UNITED STATES PATENT AND TRADEMARK OFFICE

APPLICATION NO.	FILING DATE	FIRST NAMED INVENTOR	ATTORNEY DOCKET NO.	CONFIRMATION NO.
10/070,116	02/27/2002	Udo Sohns	028-1-002	9904
27469	7590	03/10/2004	EXAMINER	
MALLINCKRODT & MALLINCKRODT 10 EXCHANGE PLACE, SUITE 510 SALT LAKE CITY, UT 84111			FITZGERALD, JOHN P	
			ART UNIT	PAPER NUMBER
			3637

Office Action Summary

DETAILED ACTION

**FIG. 4**

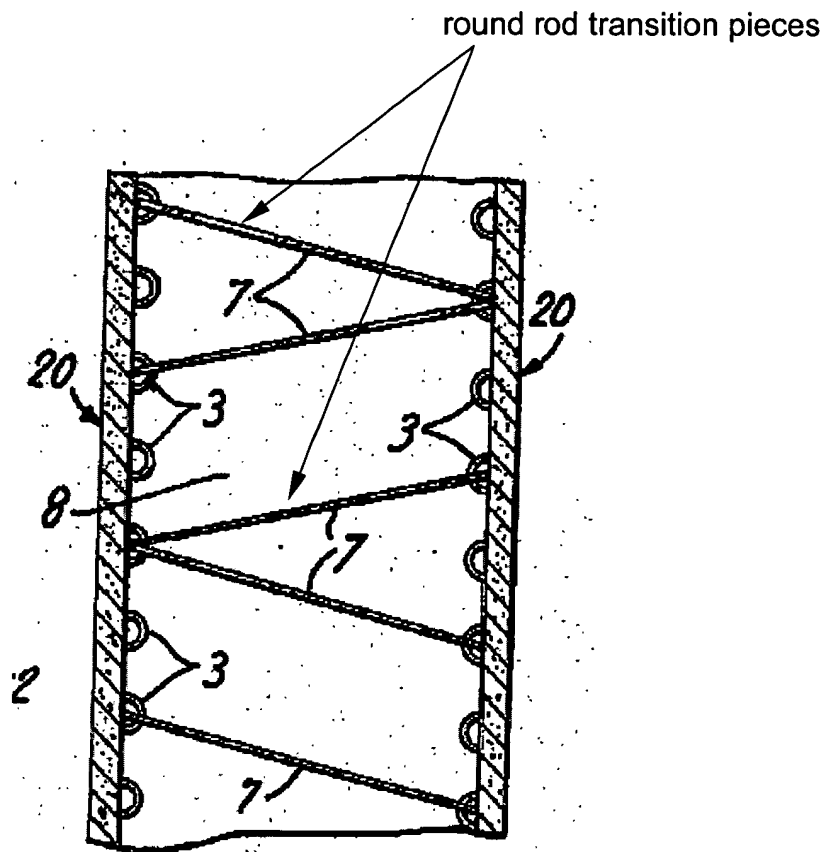
5. Claims 1, 2, 4, 5, 8 and 9 are rejected under 35 U.S.C. § 103(a) as being unpatentable over Applicant's disclosed Prior Art and Klaue. Applicant discloses a reinforced concrete section for producing foundations for building whereby the reinforced concrete section consists of two commercially available pre-cast floor elements of the same type, which each comprise a substantially rectangular concrete slab and at least one lattice girder made of steel which is attached thereto, that the two pre-cast floor elements are arranged in a laterally reversed manner so that their concrete slabs are situated parallel to at a distance from each other and their lattice girders face one another, and that the adjacent lattice girders are fixedly attached to one another by at least one transition piece being tied to its top booms. Applicant's disclosed Prior Art fails to disclose that the reinforced concrete section is formed as a single prefabricated part and each transition piece extends rigidly and in essential horizontally between the top booms of the lattice girders of the concrete slabs; wherein the lattice girders are fixedly attached to each other by welding and wherein the transition piece is a flat rod or round rod; and wherein the concrete sections being situated in a position in which they are standing on two of the their longitudinal edges and the space between the concrete slabs of the reinforced concrete sections is filled with site-mixed concrete. Klaue teaches prefabricated spaced building plates (20) with horizontally extending round rod transition pieces (7) connecting lattice points (22) and the fixedly attaching them by welding (Klaue: col. 3, lines 31-35) and wherein the concrete sections being situated in a position in which they are standing on two of the their longitudinal edges and the space

between the concrete slabs of the reinforced concrete sections is filled with site-mixed concrete (Klaue: col. 1, lines 35-40 and col. 3, lines 6-22). It would have been obvious to one having ordinary skill in the art at the time the invention was made to employ horizontally extending round rod transition pieces attached by welding, as taught by Klaue, modifying the reinforced concrete section in disclosed Prior Art, thus providing a building construction which is simple in design, rugged in construction and economical to manufacture (Klaue: col. 2, lines 35-37) and which allows variations in thickness of the walls (Klaue: col. 1, lines 69-71).
